SUMMARY REPORT

DEVELOPMENT OF AVIONICS INSTALLATION INTERFACE STANDARDS

August 1981

Prepared for
AERONAUTICAL SYSTEMS DIVISION
DEPUTY FOR DEVELOPMENT PLANNING (ASD/XR)
AND DEPUTY FOR AVIONICS CONTROL (ASD/AX)
WRIGHT-PATTERSON AIR FORCE BASE
DAYTON, OHIO 45433
under Centract F04606-79-G-0082-S706

Figure 6-7. REVISED VIBRATION SPECTRUM

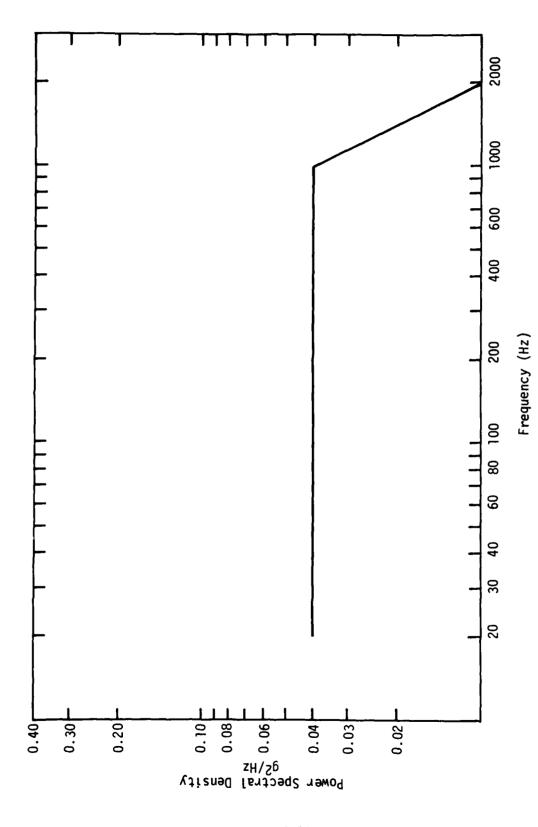
As a result of the open forum recommendations, the vibration-environment requirements were revised to state that the avionics rack location and design should control vibration input not to exceed 0.04 $\rm G^2/Hz$ from 20 Hz to 1,000 Hz, as shown in Figure 6-7.

Figure 6-8. COOLING AIR FLOW REQUIREMENTS FOR ALTERNATE COOLING AIR BULK INLET TEMPERATURES

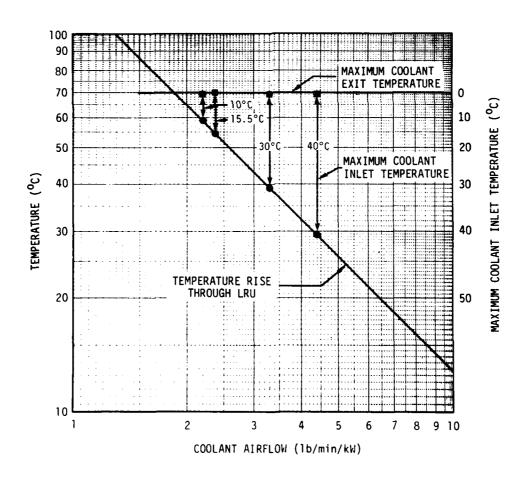
The open forum recommended clarifying ECS design requirements. It was considered necessary to specify a schedule of mass flow versus inlet bulk air temperature to ensure that the ECS can deliver sufficient cooling flow to maintain avionics LRU exhaust temperatures below 71°C. The required relationships are shown in Figure 6-8.
